Staff Report Addendum

Date: October 3, 2025
To: Douglas County Planning Commission
From: Trevor Bedford, AICP, Senior Planner *TB*
Jeanette Bare, AICP, Planning Manager *SK for JB*
Steven E. Koster, AICP, Assistant Director of Planning Services *SK*
Subject: River Canyon Filing 2, 3rd Amendment, Lot 2A-1
Project File: LE2025-018

Project Name: River Canyon Filing 2, 3rd Amendment, Lot 2A-1

Project File #: LE2025-018

1 EX STORM 01 - STORM 01
C-103 HOR: 1"=20' VERT: 1"=4'

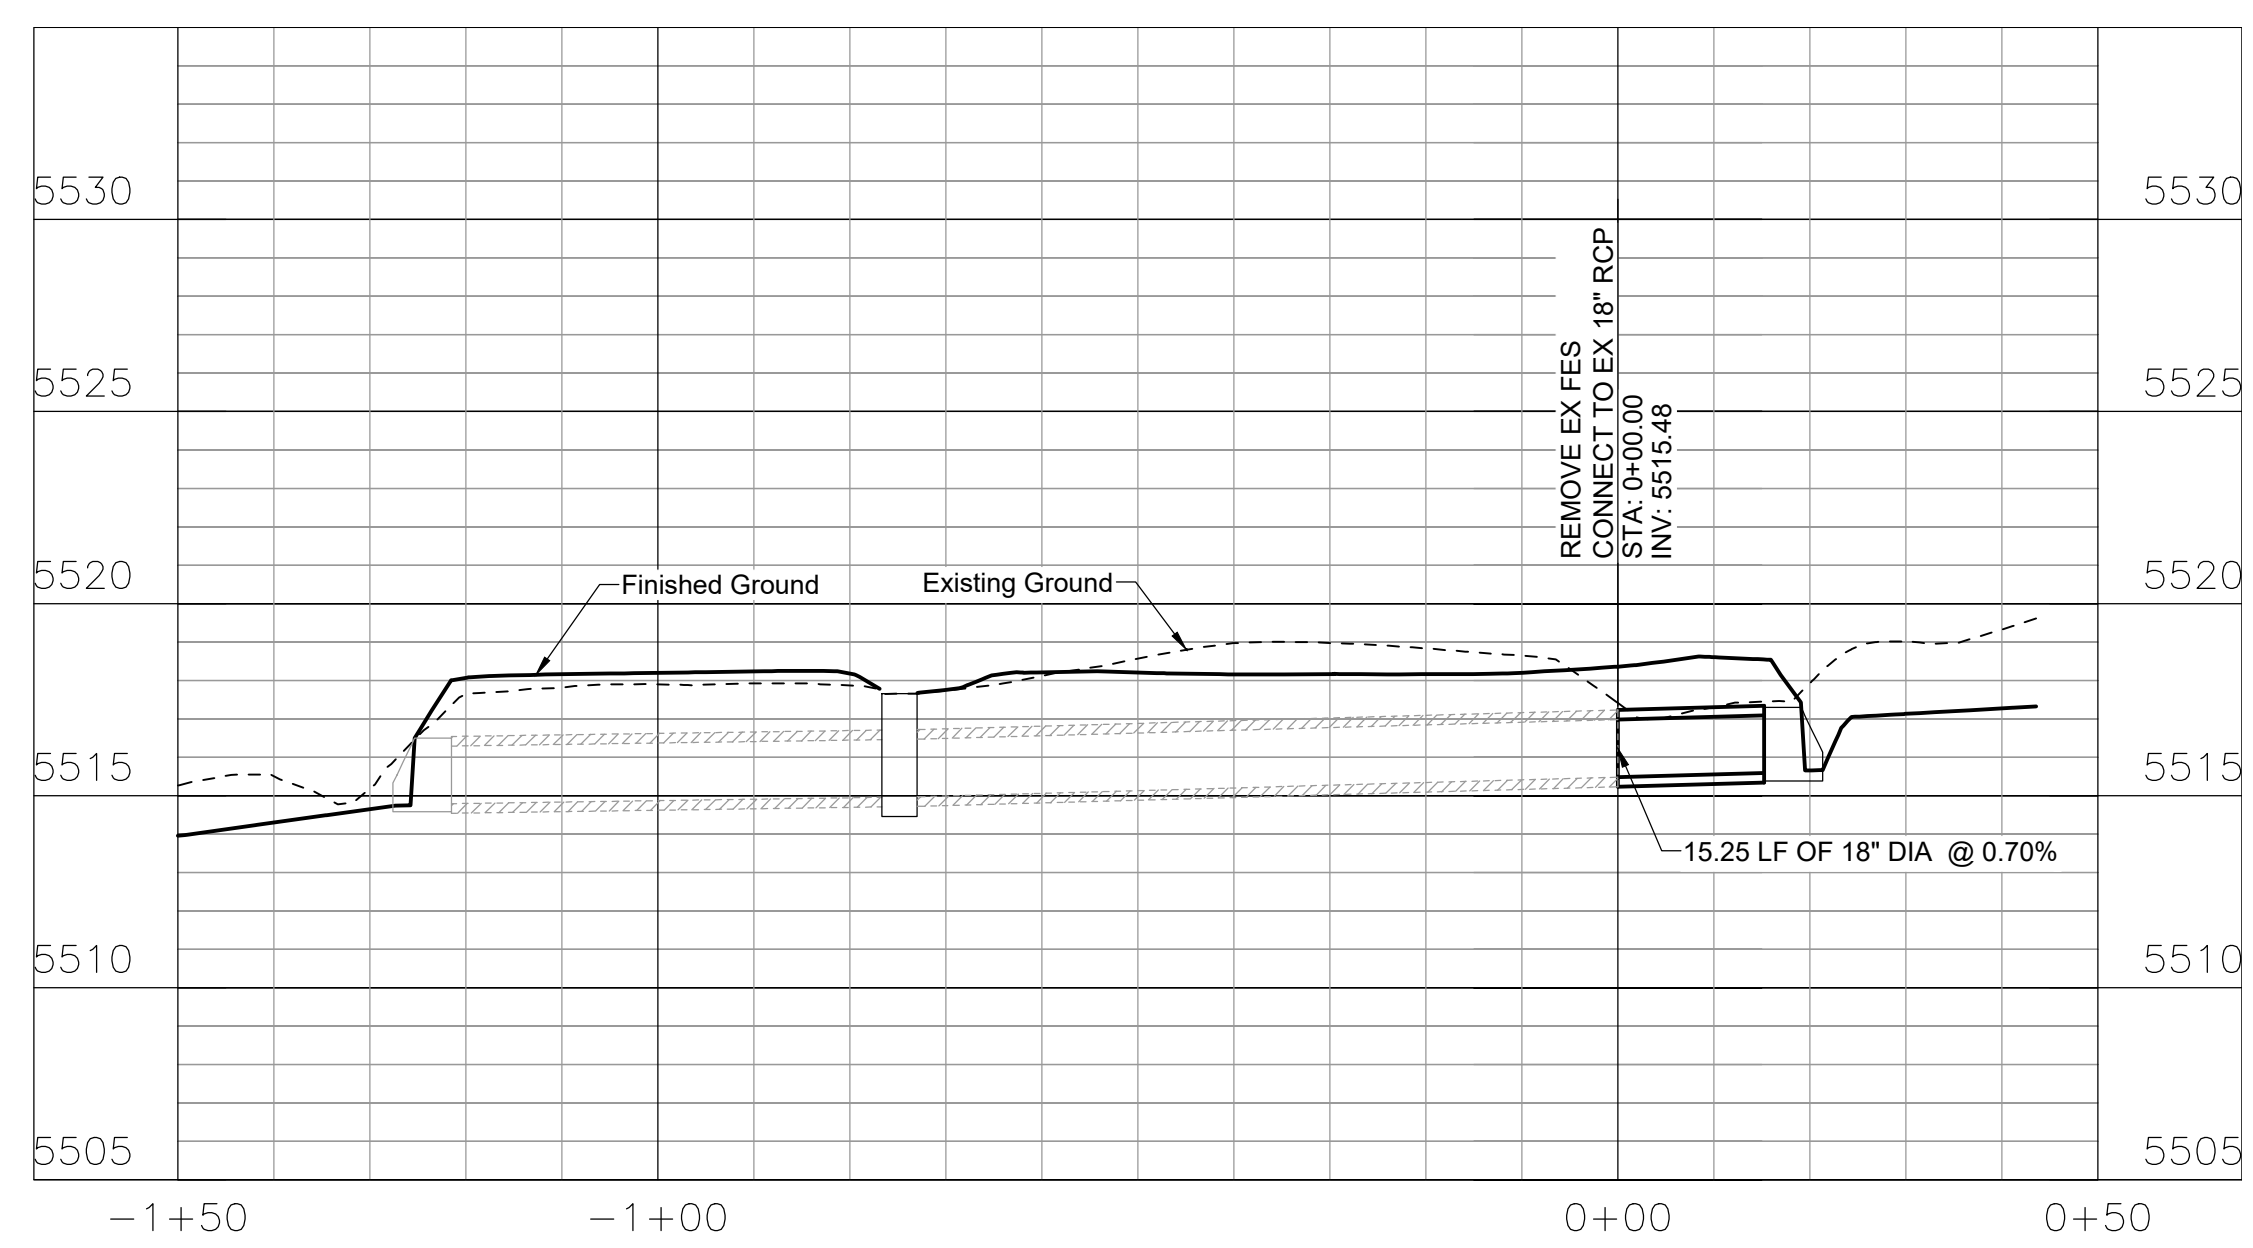
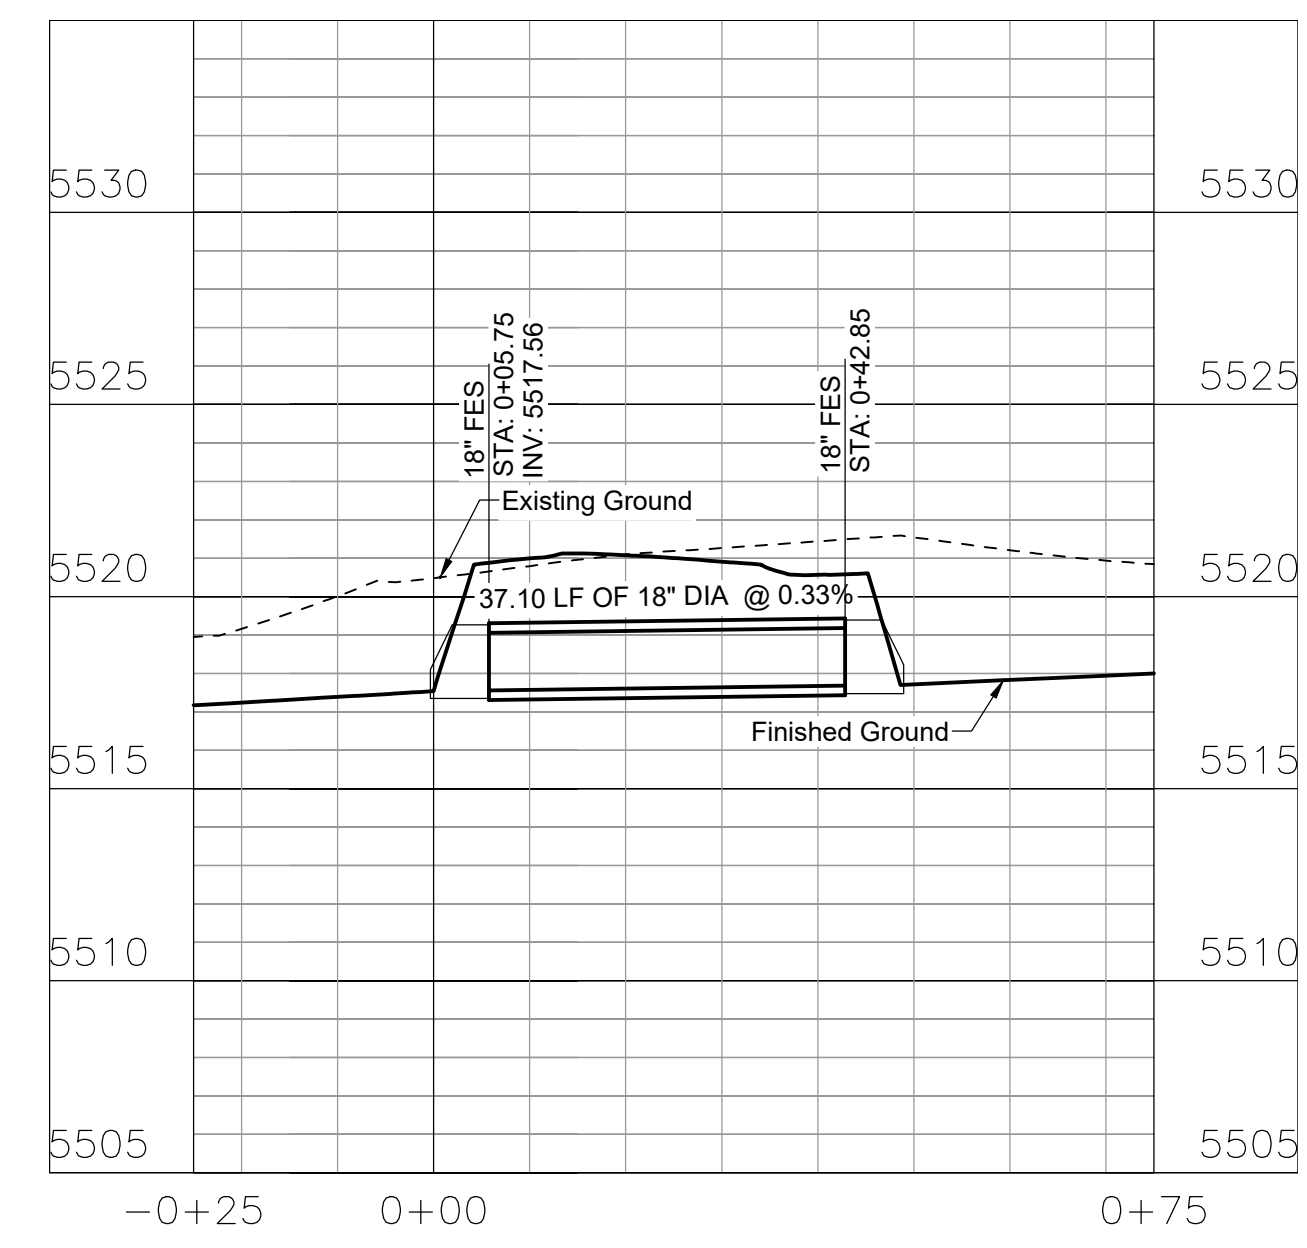
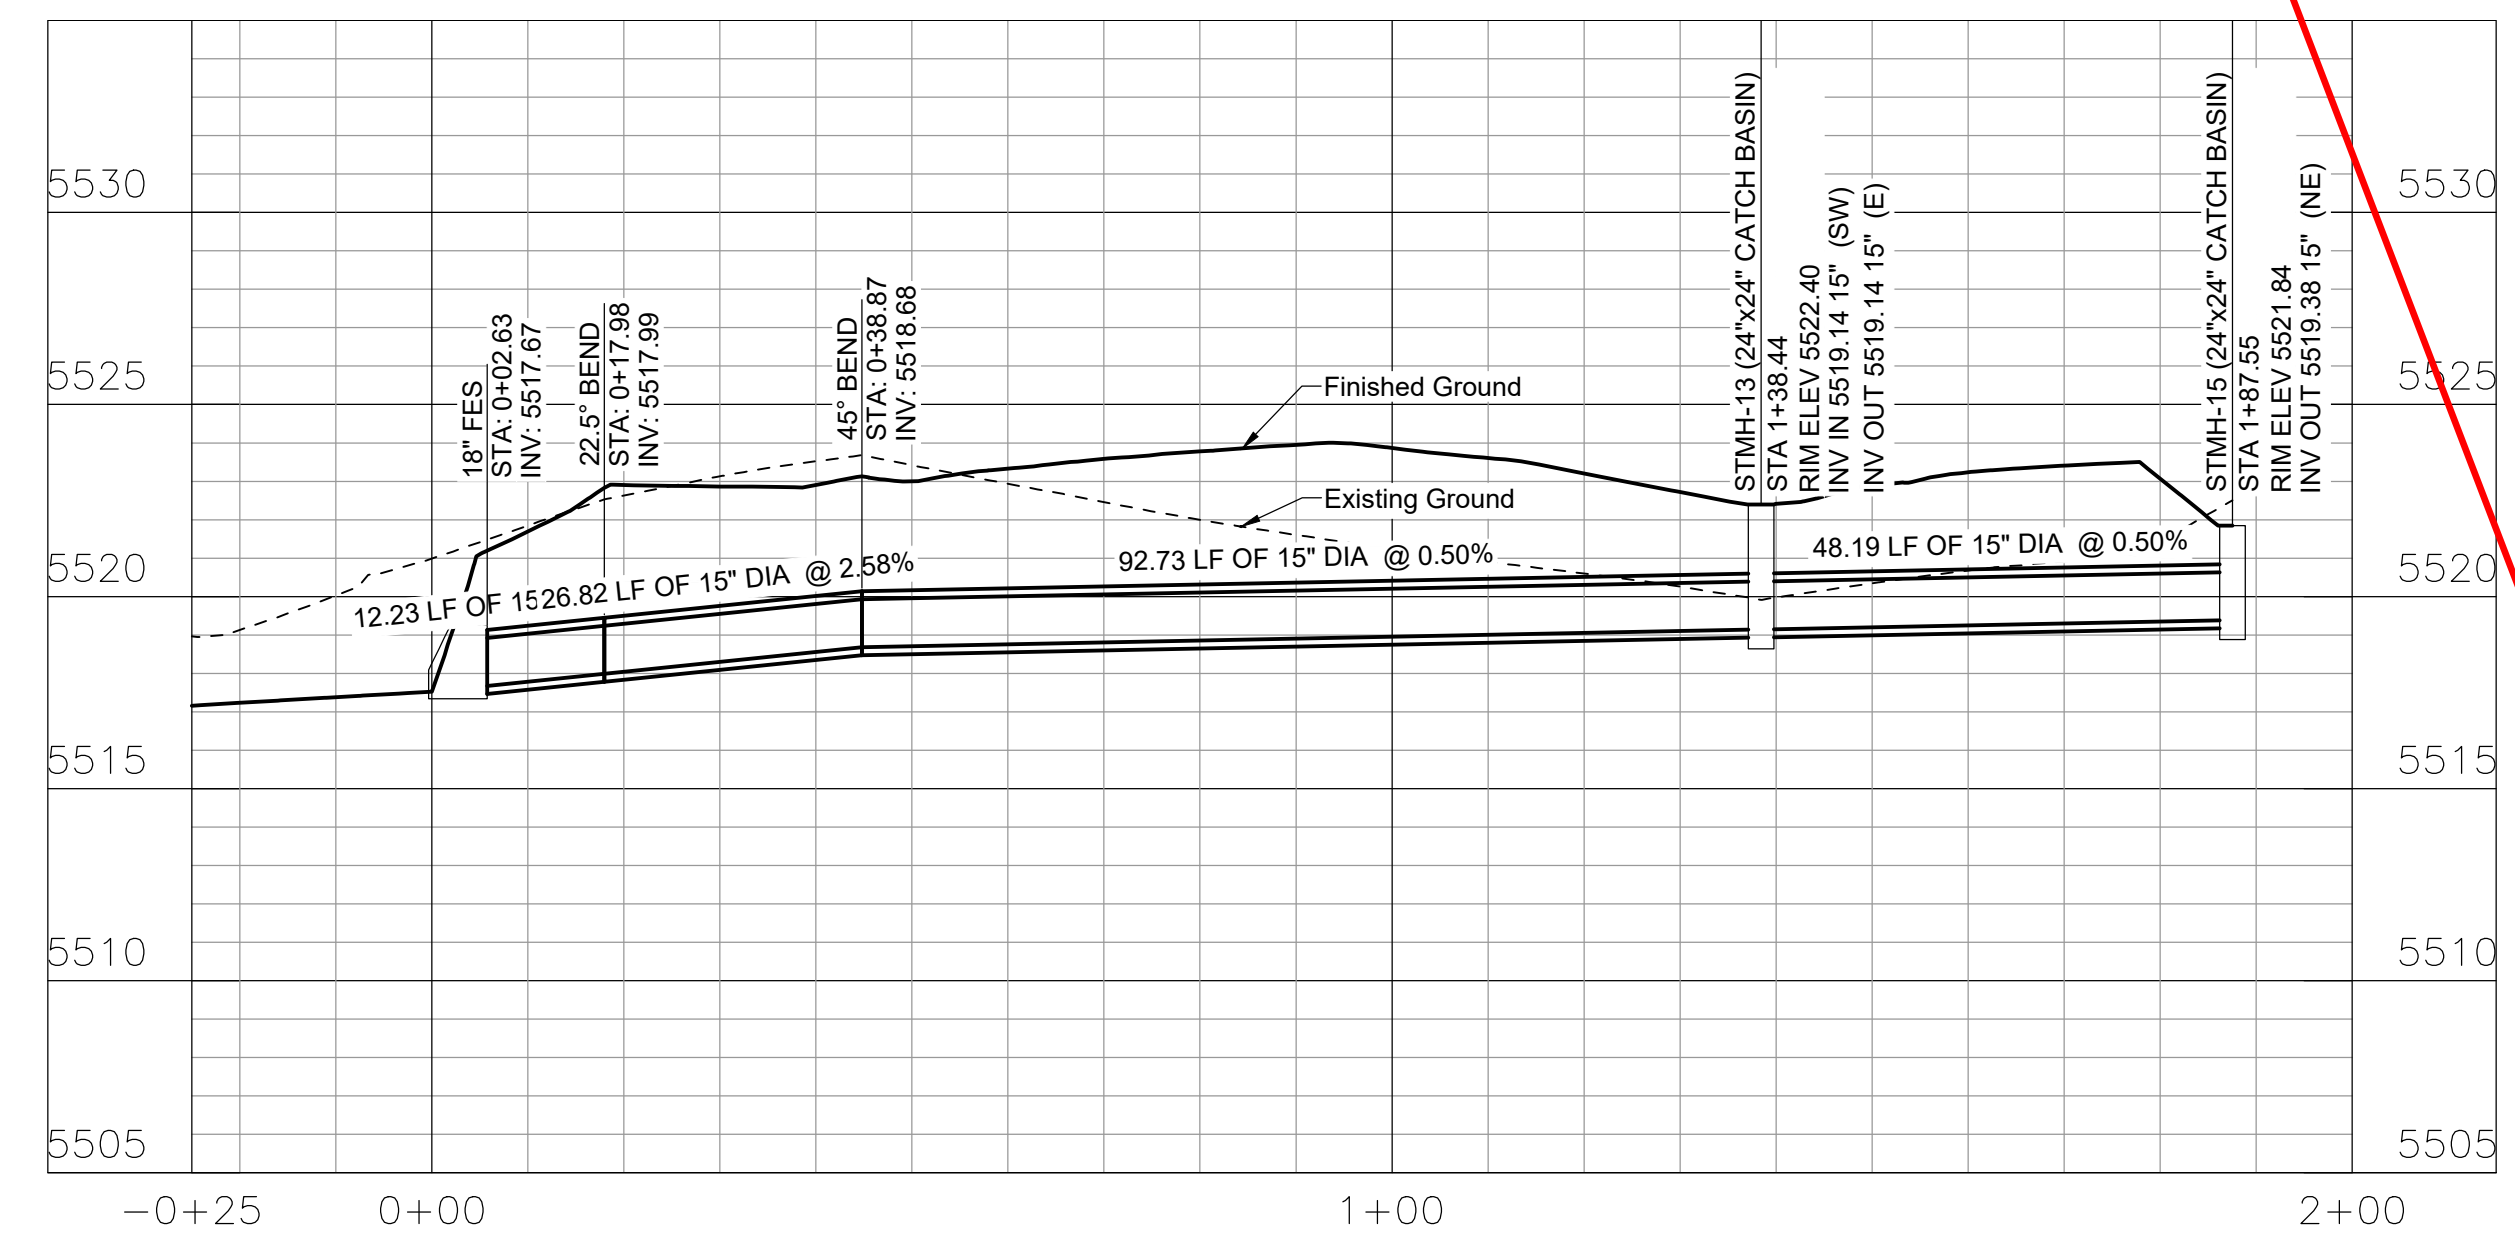
Relocate the Douglas County Acceptance Block to the lower right corner of the sheets (typical comment)

Specify the pipe material (typical comment)

Project No.:	181301899		
File Name:	01899C - DRAINAGE PLAN		
Scale:	SCALE		
EM Dwn.	EM Dsgn.	JC Chkd.	2025.08.18
YYYY.MM.DD	YYYY.MM.DD	YYYY.MM.DD	YYYY.MM.DD
Title DRAINAGE PLAN			
Revision:	Sheet:	1 of 1	
Drawing No.

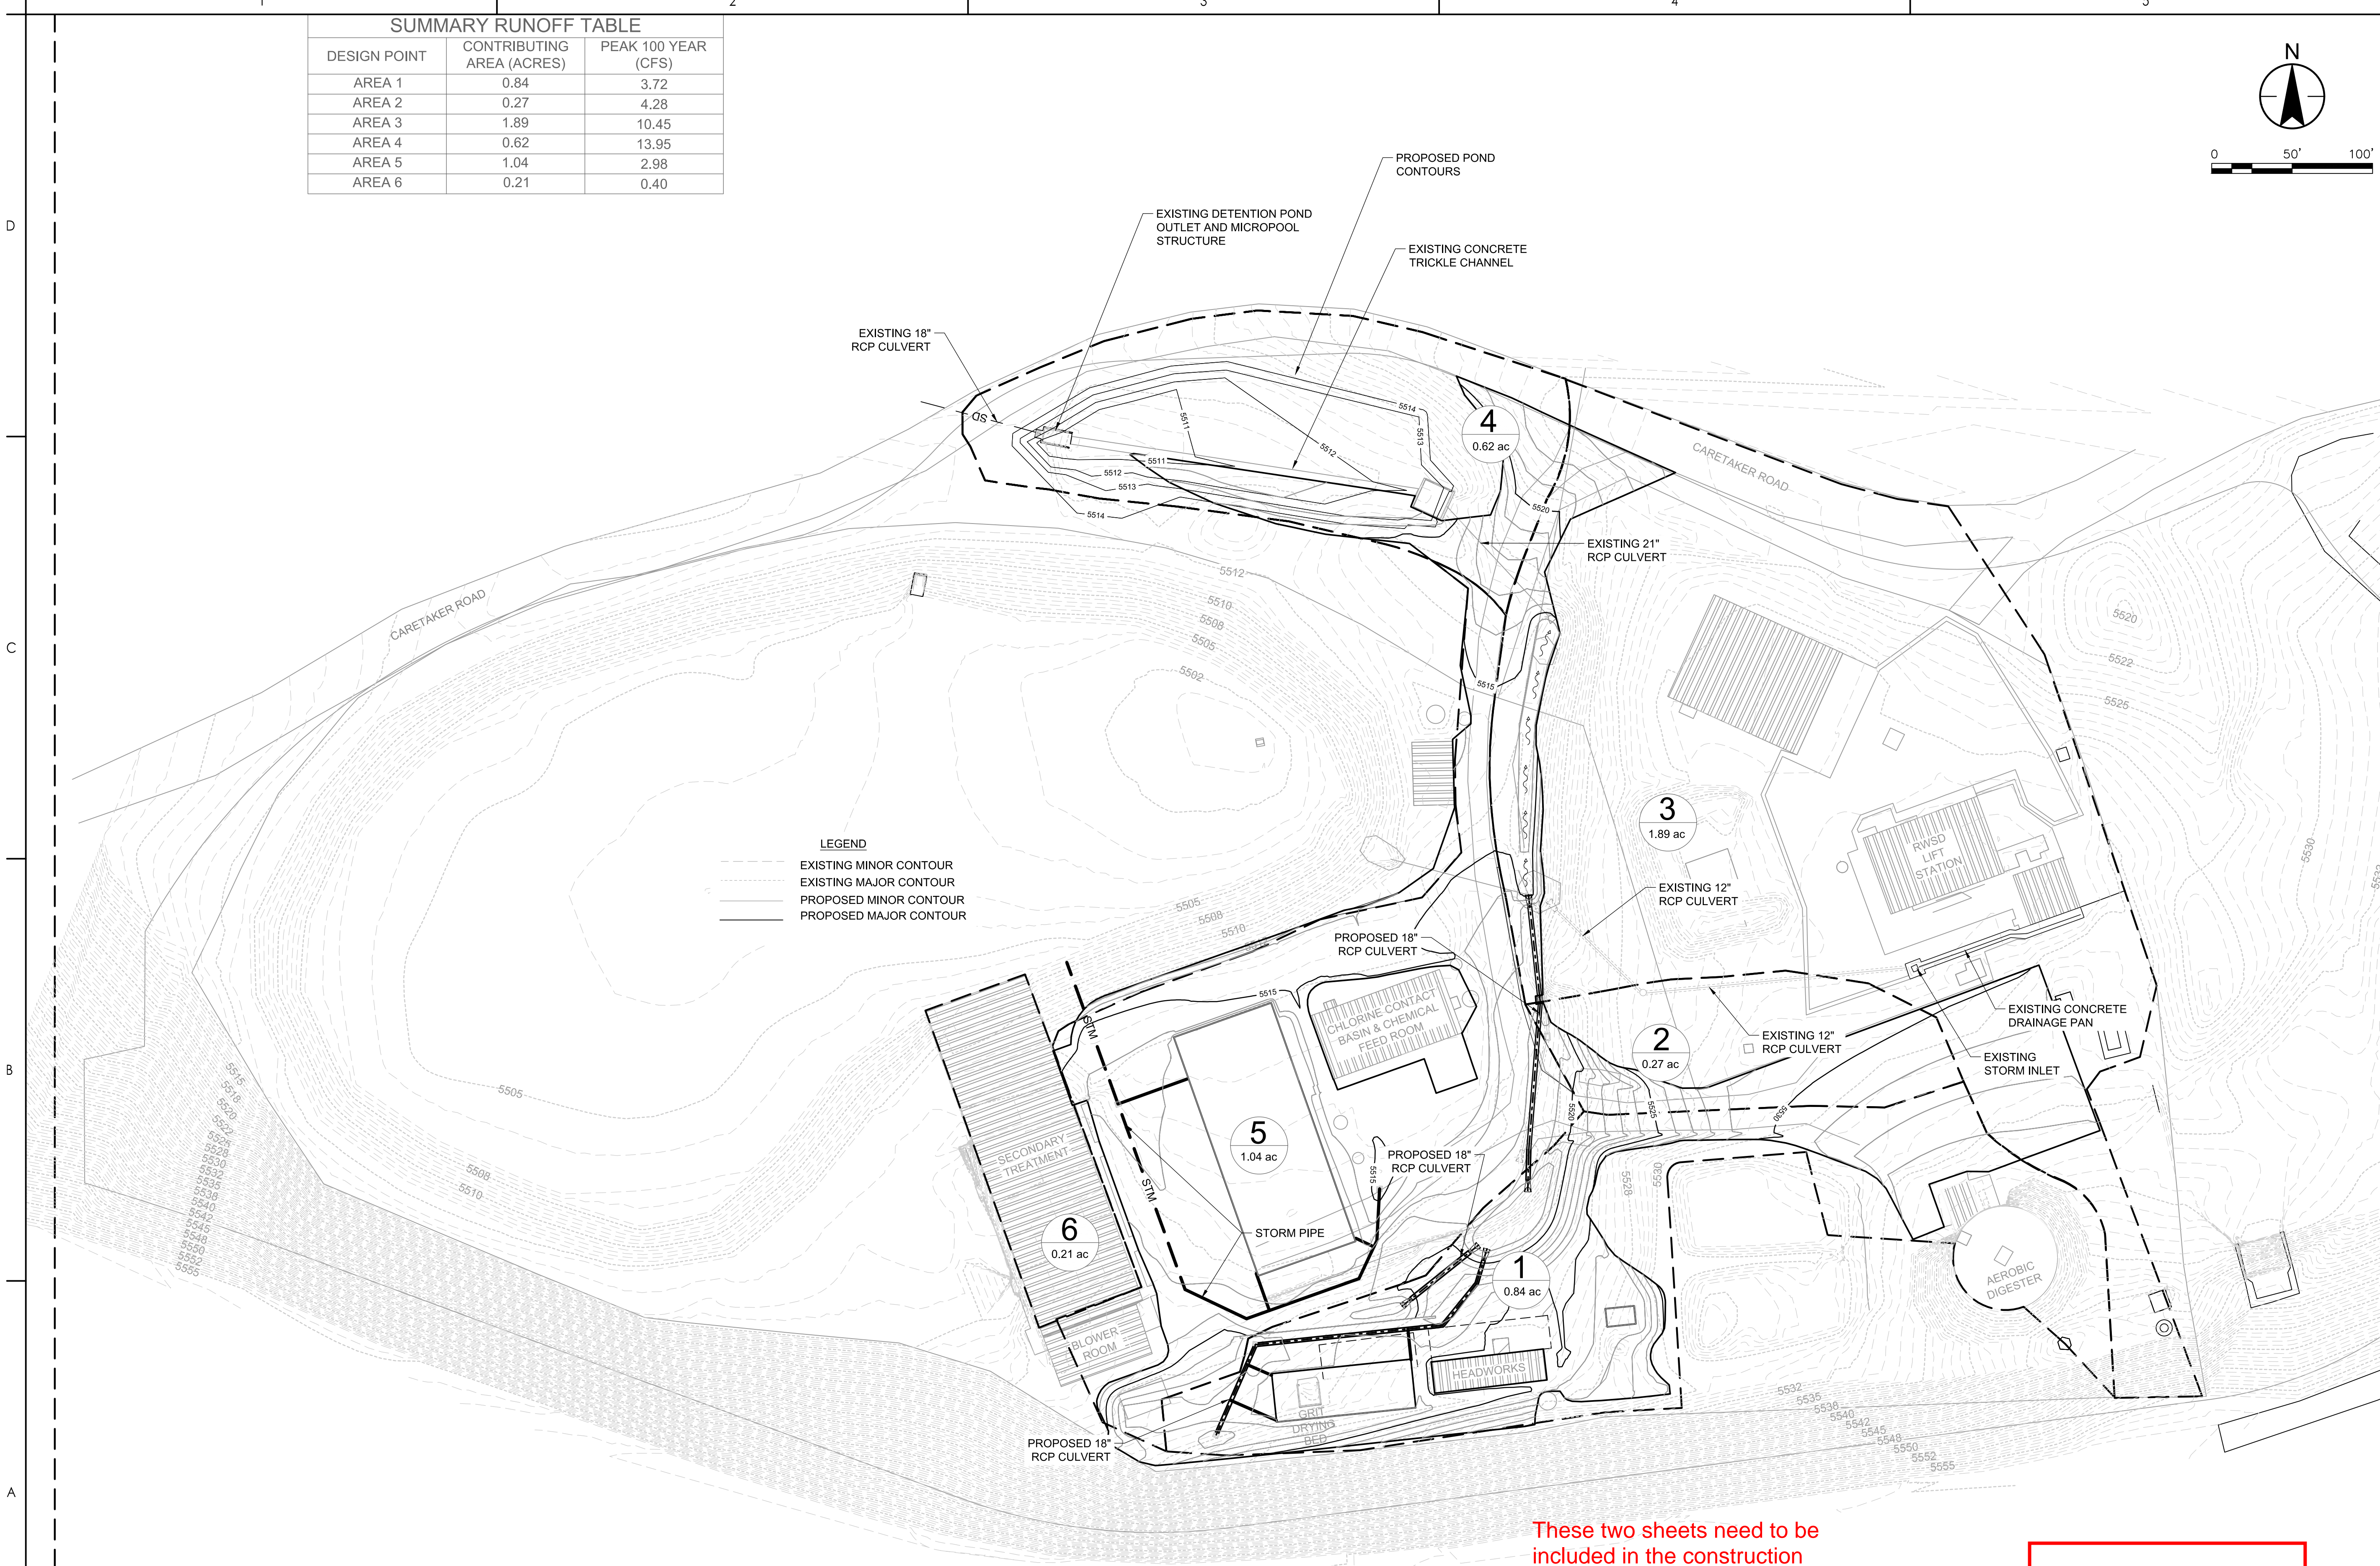
These two sheets need to be included in the construction plan package

Add the Douglas County Acceptance Block to this sheet
